DATE:	February 2, 2026
TO:	Town of Troy Plan Commission
FROM:	Robert Jones
REGARDING:	Preliminary Plat – Glen Acres – PID 040-1159-80-200

PRELIMINARY COUNTY PLAT OF

GLEN OAKS

REGARDING: Engineering Review Comments – Glen Acres – PID 040-1159-80-200

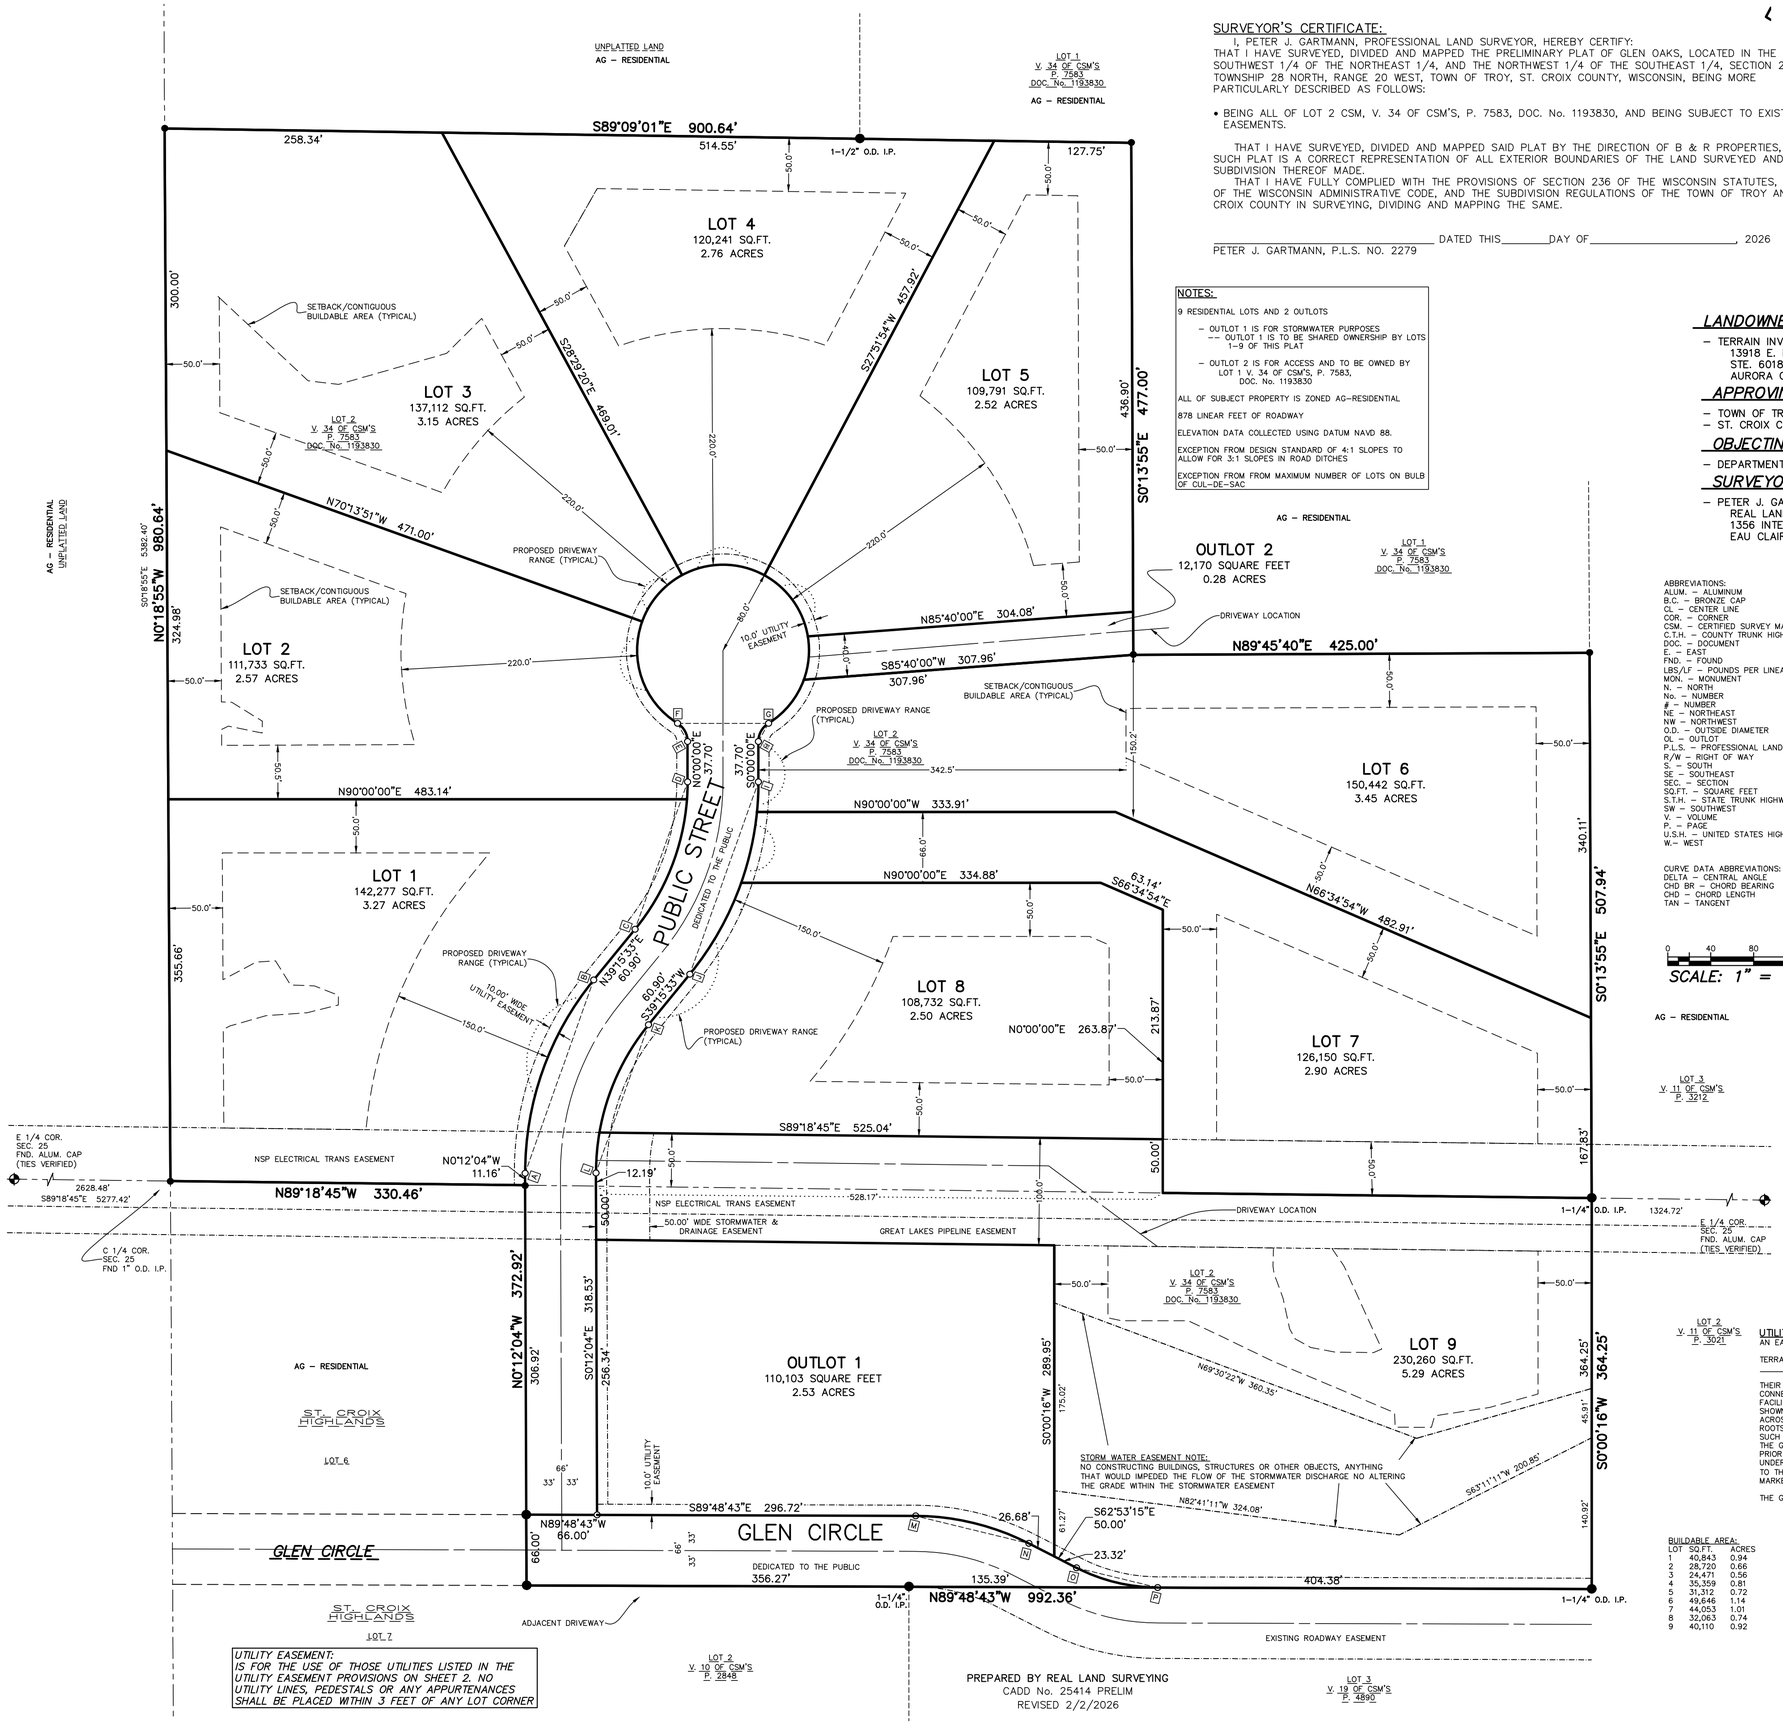
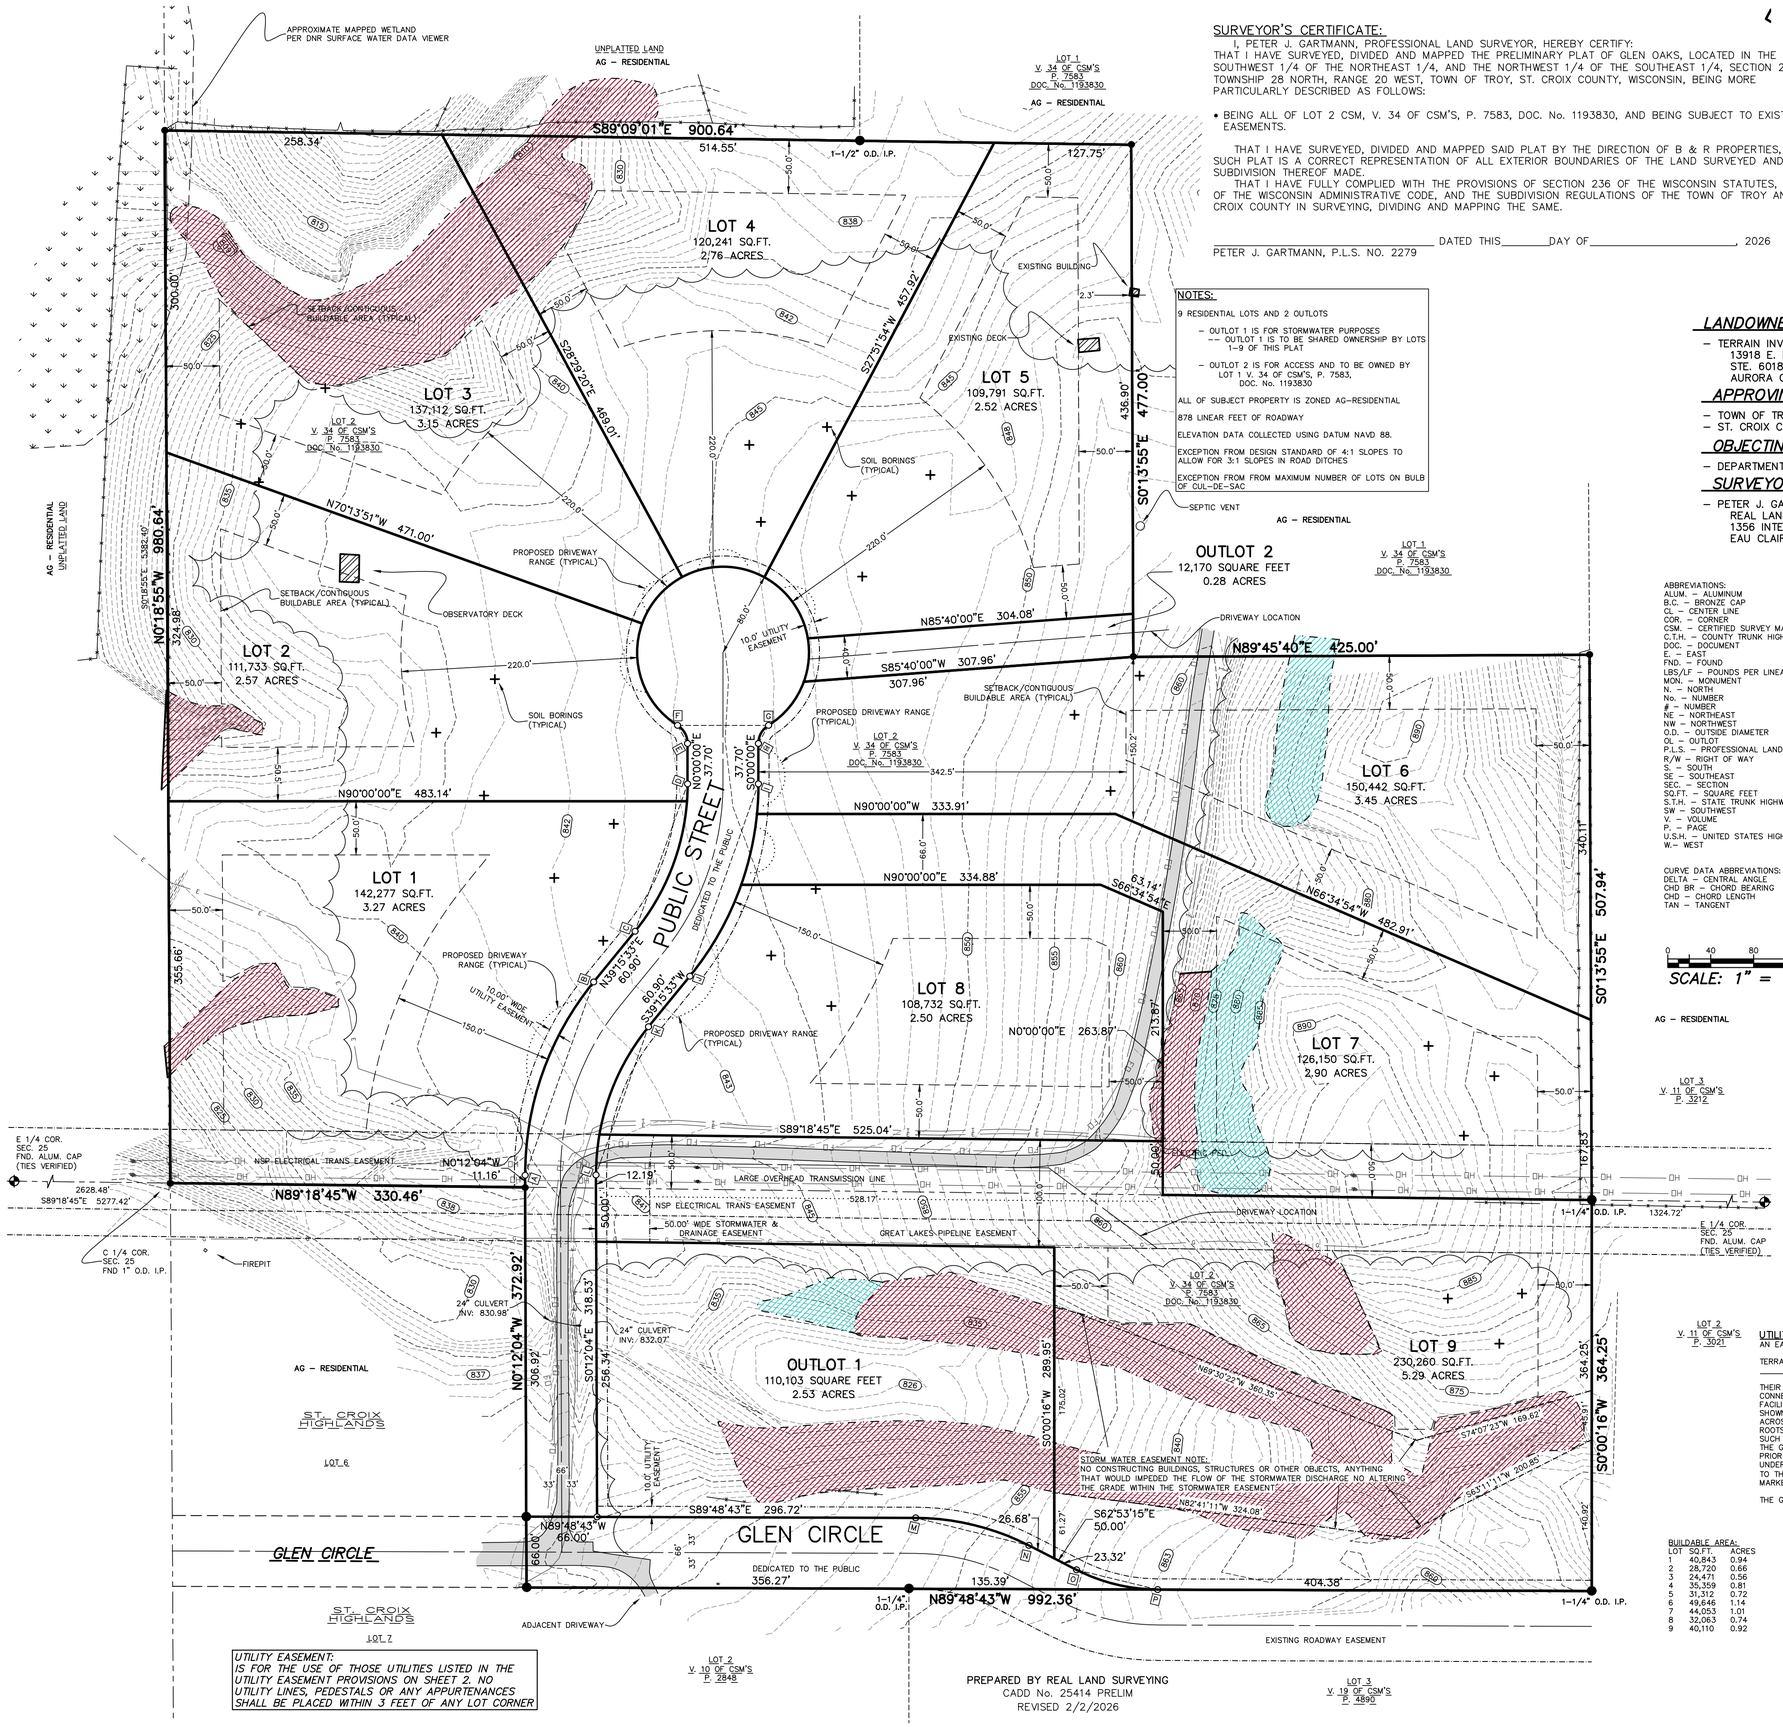
1. **Minimum Lot Area Compliance**
   Revise the preliminary plat to demonstrate that all residential lots exceed the 2.50-acre minimum required for AG-RES subdivisions, or otherwise document compliance through an approved cluster subdivision framework.
   - Preliminary plat has been revised to show 2.5-acre minimum lot sizes.

2. **Driveway Locations**
   Show proposed driveway locations for all lots on the preliminary plat. If flexibility is requested for wide lots, provide an alternative approach acceptable to the Town Engineer (e.g., driveway envelopes or worst-case culvert sizing assumptions).
   - AEC will design culverts for worst case scenarios on each lot and specify these on the civil plan.
   - General range of locations of where this could be placed for a driveway will be shown on the preliminary plat.

3. **Outlot Ownership and Purpose**
   Clarify ownership, access rights, and long-term maintenance responsibility for:
   a. Outlot 1 (stormwater) – provide reference to external documents detailing the ownership and responsibility for this parcel (to be detailed and developed through further discussion with Town and County staff).
   - We are proceeding with the outlot for stormwater being a 1/9th ownership split and will be shown/ noted in the stormwater maintenance agreement this way which has been attached to this resubmittal.

b. Outlot 2 (access) – clearly identify ownership, benefited parcel(s), and maintenance obligations.
   - Property will be dedicated to adjacent landowner and is stated on the plat as such.

4. **Exceptions to Design Standards**
   Please list all requested Exceptions to Design Standards directly on the Preliminary Plat. These are currently known to include:

a. § 135-6.G.10 Maximum number of lots on bulb of cul-de-sac
      - This is a requested exception request, all lots meet the minimum area and have a greater setback around the cul-de-sac so we should be able to exceed the max number of lots on a cul-de-sac bulb.

b. § 125-14.J(9) 3:1 slopes with Town Board Approval
      - This was explained in the Town planning commission meeting and was generally agreed to based on our restrictions and the adjacent lot not being able to be graded into. Generally speaking, the grades should be mowable at a 3:1 slope and there are many areas within the

c. § 135-6.G.9 Lots with side and rear setbacks less than 50-feet

1. Consider adding a sign detail for "end of roadway" signage.
    a. AEC has specified a specific sign per MUTCD.
2. Stormwater/drainage easement shown on Lot 9

a. Drainage easement will be added to the south side of Lot 9 to account for offsite drainage on the preliminary plat.
3. Building setback callouts or inclusion in the legend

a. Building setback & buildable area callout with "TYPICAL" on Lot 2 of the final plat which will be copied onto the Preliminary plat.
4. Replace preliminary plat "notes" with the notes included on the final plat submitted 1/28 (e.g., HOA and Exceptions to Design Standards)

- This has been revised to show 50-feet on all lots.
